## Flood Damage Reduction Segment / System Inspection Report

Name of Segment / System: Souris River - Minot - Left Bank

Inspection Start Date: 10/30/2019

- ☐ Initial Eligibility Inspection  
☒ Continuing Eligibility Inspection (Routine)  
☐ Continuing Eligibility Inspection (Periodic)

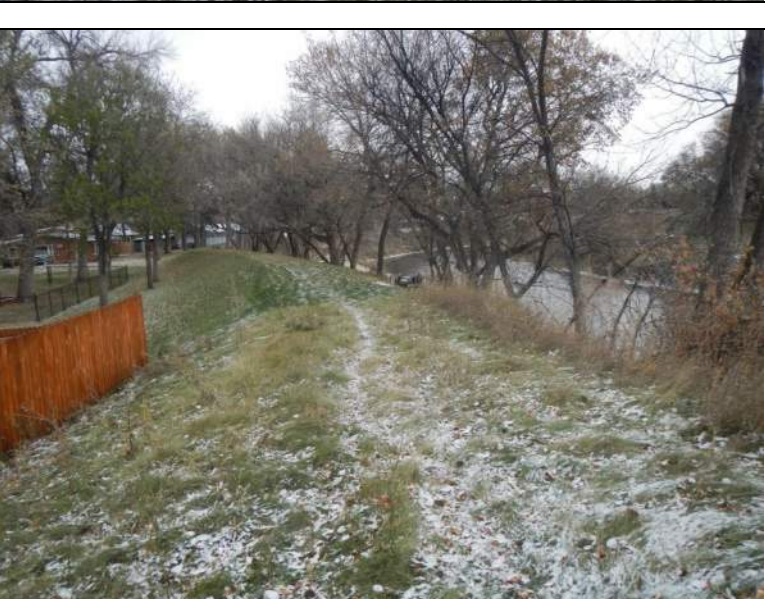
<p><b>Inspect ID:</b> MINL_2019_a_0122 <b>Title:</b> USACE_CEMVP_MINL_2019_a_0122_1.jpg <b>Rated Item:</b> 1. Unwanted Vegetation Growth <b>Caption:</b> Rating: Unacceptable; Remarks: Overgrown vegetation along the zoo fence; Action: Remove unwanted vegetation from vegetation-free zone, up to the levee easement. Remove root ball, backfill, compact in lifts, and reseed with grass; Station_1: 02+96L; Station_2: 09+81L</p>
	<p><b>Inspect ID:</b> MINL_2019_a_0122 <b>Title:</b> USACE_CEMVP_MINL_2019_a_0122_2.jpg <b>Rated Item:</b> 1. Unwanted Vegetation Growth <b>Caption:</b> Rating: Unacceptable; Remarks: Overgrown vegetation along the zoo fence; Action: Remove unwanted vegetation from vegetation-free zone, up to the levee easement. Remove root ball, backfill, compact in lifts, and reseed with grass; Station_1: 02+96L; Station_2: 09+81L</p>
